1 What is new in EKC V2.5?

Operating system of the machine: V_EKC_002.005.000_STOLL

Release: 08/2022

Comparison of "Narrow and standard yarn carrier tip"

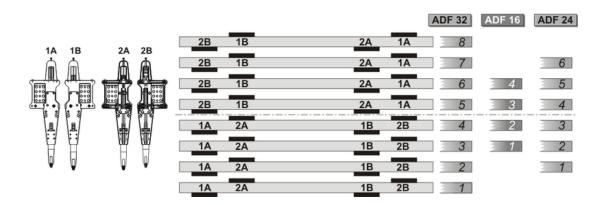
For the plating is a narrow yarn carrier tip available. A yarn carrier can then be adjusted lower, for example with Devoré and ikat plating.

There are two yarn carrier bows with narrow yarn carrier tip available:

Yarn carrier bow for yarn carrier 1A, 2B	281 757
Yarn carrier bow for yarn carrier 1B, 2A	281 758

Exchange the yarn carrier bow of an available yarn carrier with the yarn carrier bow with narrow yarn carrier tip.
